**CIRCLE K AT HIGHWAY 24 & MERIDIAN ROAD
CONSTRUCTION DOCUMENTS**
EL PASO COUNTY, COLORADO
SEPTEMBER 2022

PCD FILING NO.: PPR2230

CONSTRUCTION DOCUMENTS

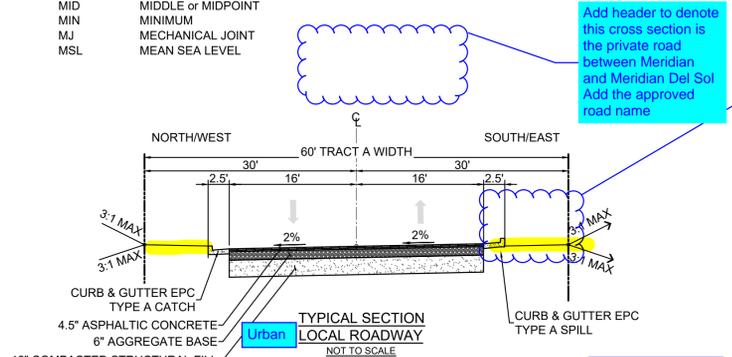
Add EPC Std Design Detail
2-41

SHEET TITLE:
PAVEMENT PLAN

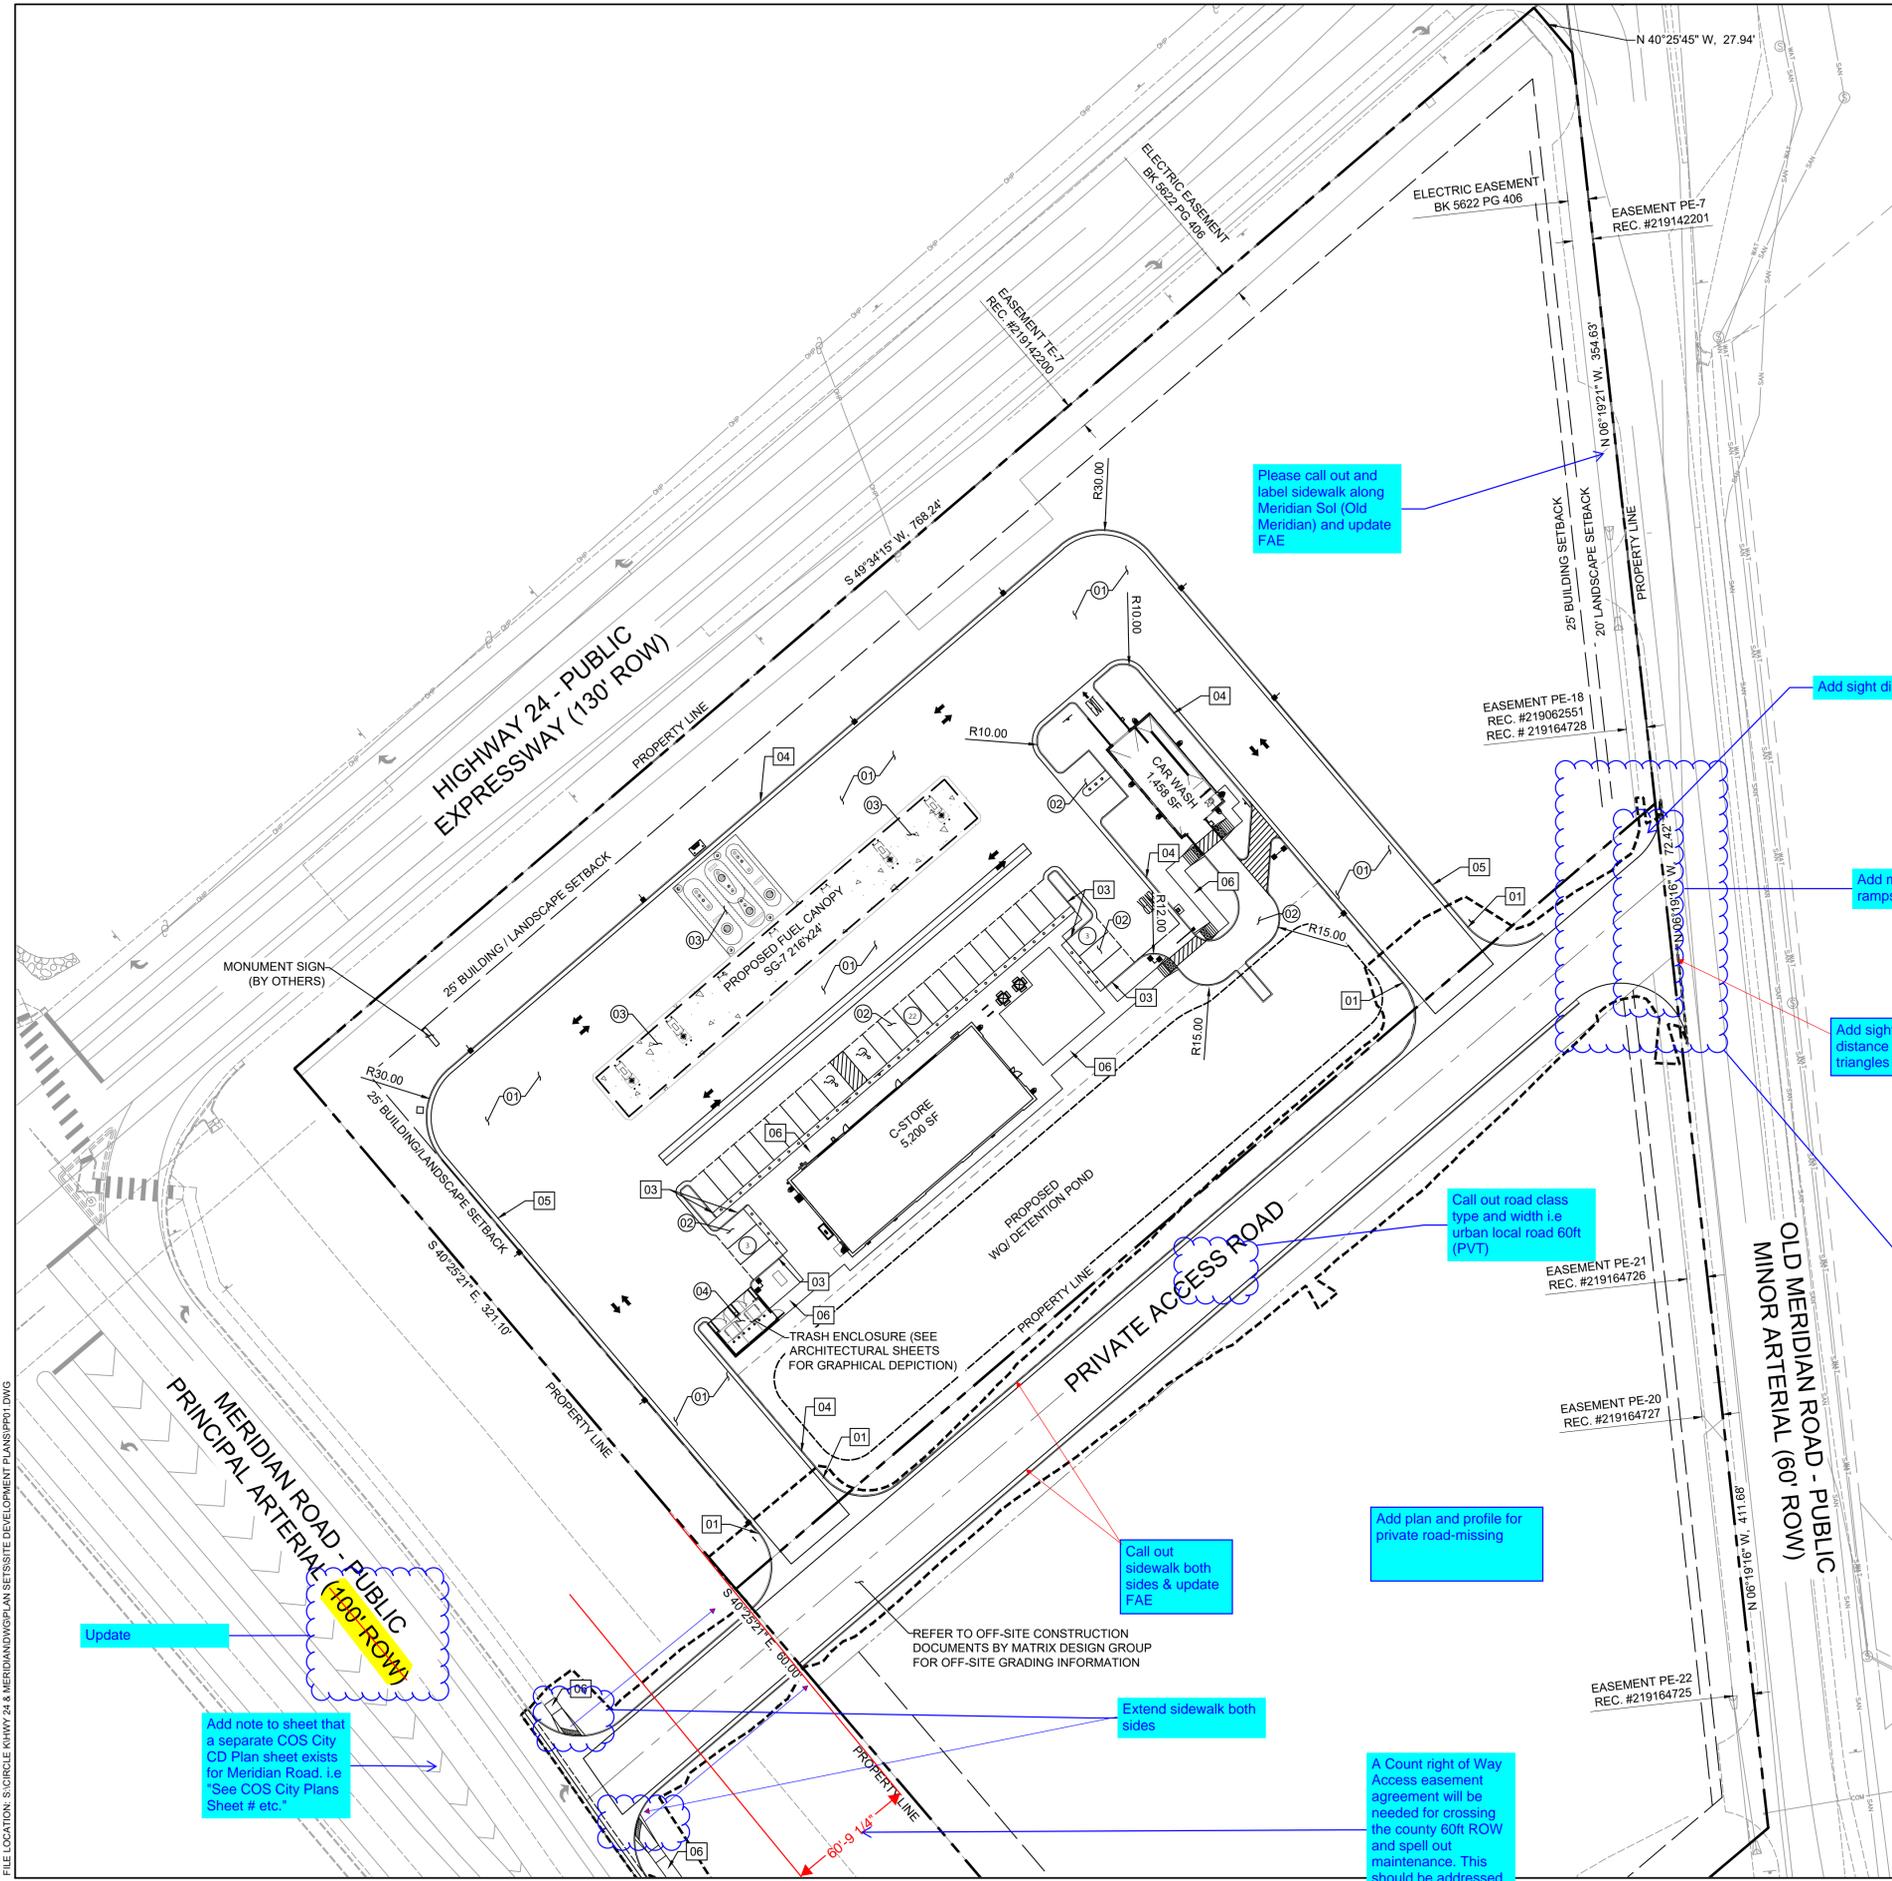
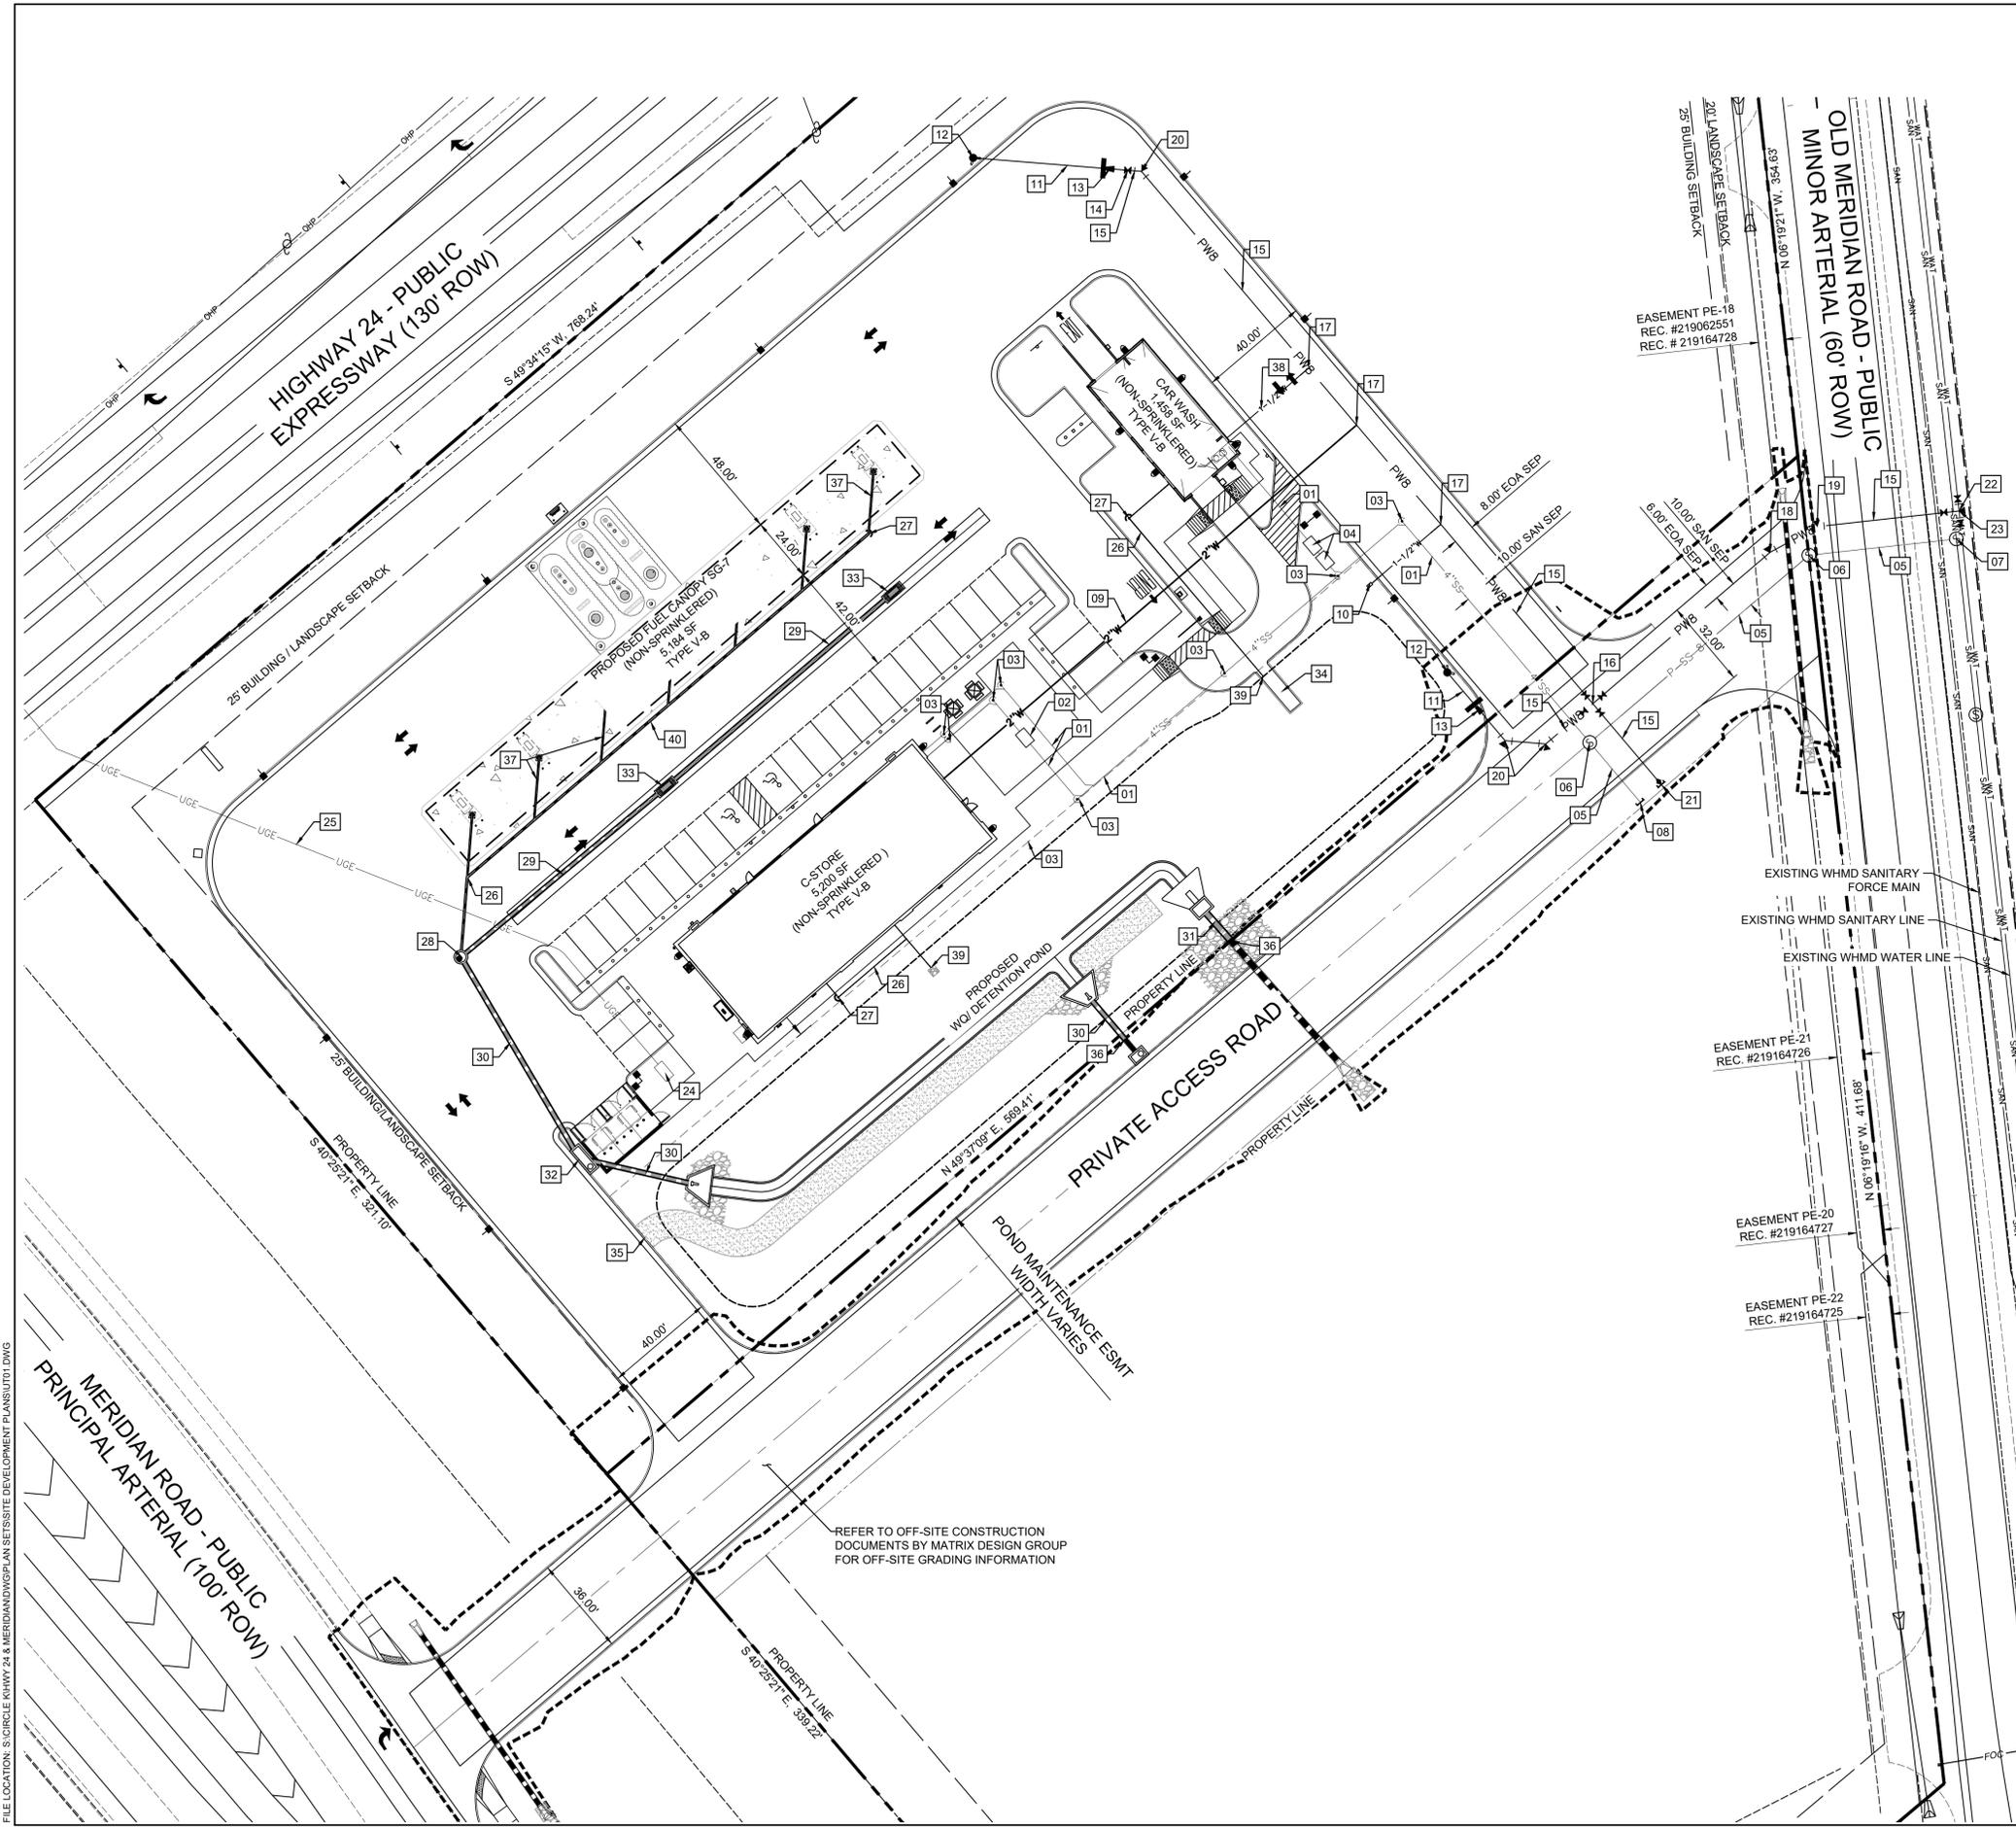
Add sight distance

Add missing ped ramps

Add sight distance triangles

Add plan and profile for private road-missing

A Count right of Way Access easement agreement will be needed for crossing the county 60ft ROW and spell out maintenance. This should be addressed in VR223

Address road intersection angle ECM 2.4.1.C Horizontal Alignment. Access points shall be aligned at 90 degrees to the adjacent road centerline or along a radial line in a cul-de-sac. No deviation(s) has been submitted.

Add note to sheet that a separate COS City CD Plan sheet exists for Meridian Road. i.e "See COS City Plans Sheet # etc."

STORM DRAIN PLANS

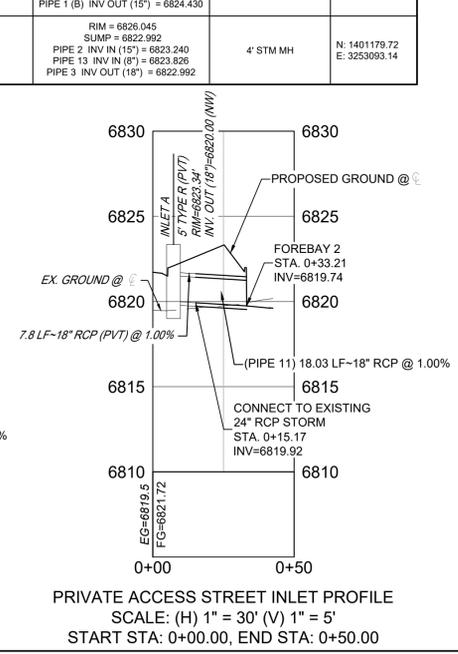
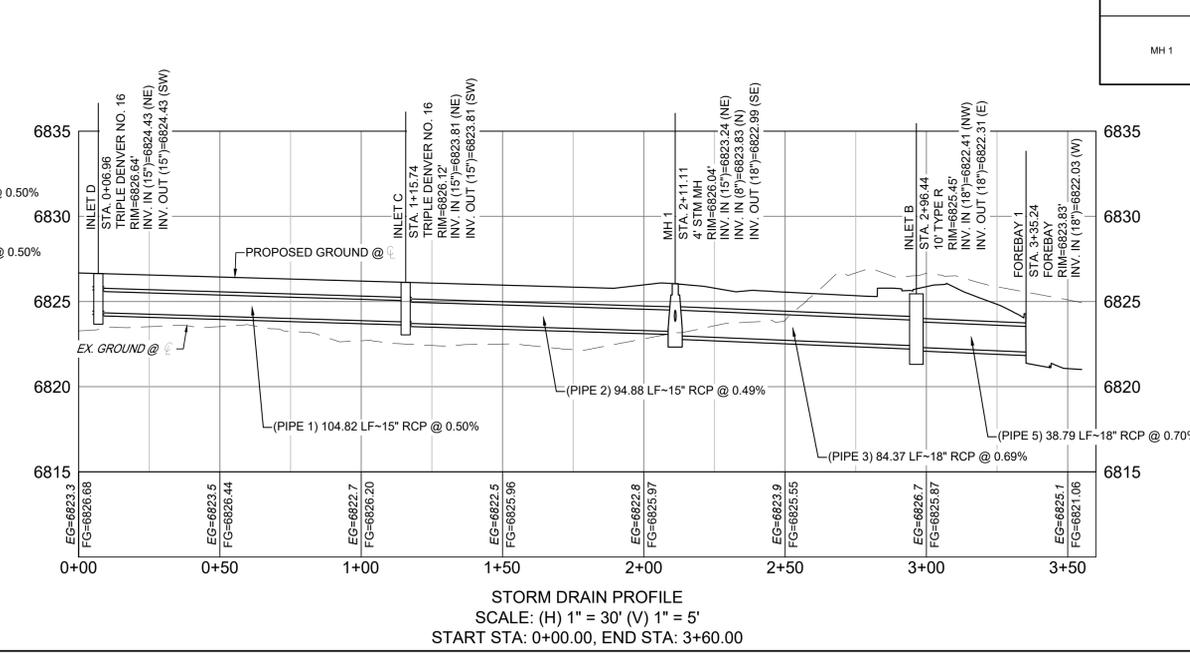
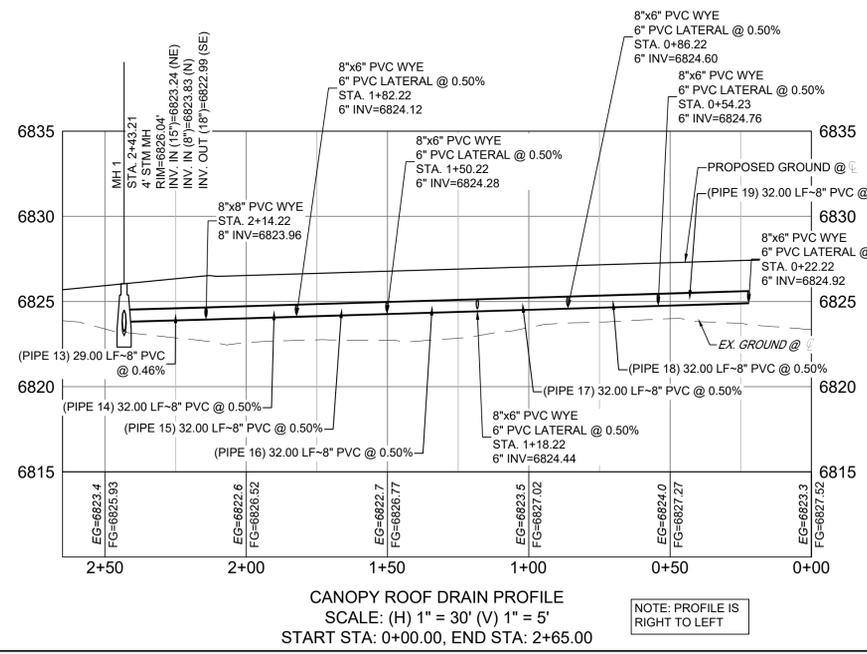
Please provide more information on how to find these documents: the drawing date, the project name, etc. Or if they are somewhere in this planset, provide the sheet number(s).

**SIGNING &
STRIPING PLAN**

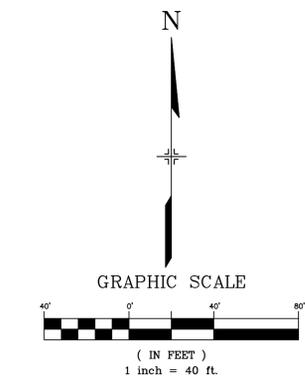
Add note to sheet that a separate COS City CD Plan sheet exists for Meridian Road, i.e. "See COS City Plans Sheet # etc."

Add stop sign

Add speed limit sign-dual facing

Add no left turn sign

Denote 3/4 Movement controls with westbound left hand turns restricted Show signage and lane markings. No left turn per TIS

Add stop sign
